Title: Coldharbour Farm Flood Risk

Date: 27th February 2026

Revision: P02

1.0 Introduction

Figure 1. Areas to be raised/lowered in Outline Application

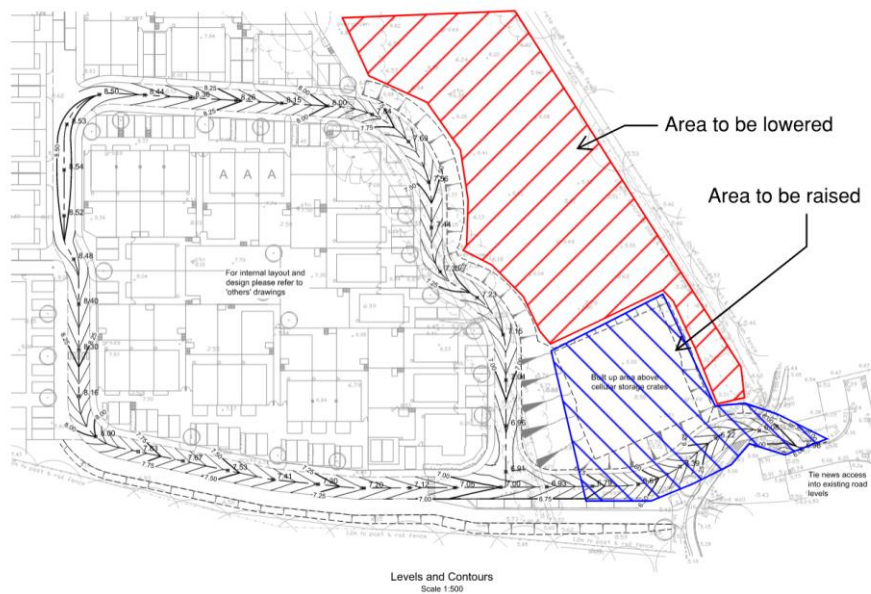
We require the applicant to complete a floodplain storage compensation assessment of the proposed variation to condition 2. This is necessary to prevent the new development reducing flood plain storage capacity and displacing flood waters, thereby increasing flood risk elsewhere. Floodplain compensation should be provided on a 'level for level' basis, calculating the replacement of volumes lost from the floodplain through development by reducing nearby ground levels. The compensatory volume must be at the same level, or provide a betterment, as the lost storage.'

- 2.1.1 The original Flood Risk Assessment was undertaken by Bellamy Roberts in September 2022. Revision MT/5314/FRA.5 was approved as part of the outline planning permission.
- 2.1.2 Within the original FRA, a flood compensation area was required due to the raising of levels around the proposed access point to the site. It was calculated a compensatory volume of 976.2m³ would be required to compensate for the level raising around the access. A volume of 1,170m³ was provided in the area to the immediate north of the access/attenuation tank area.
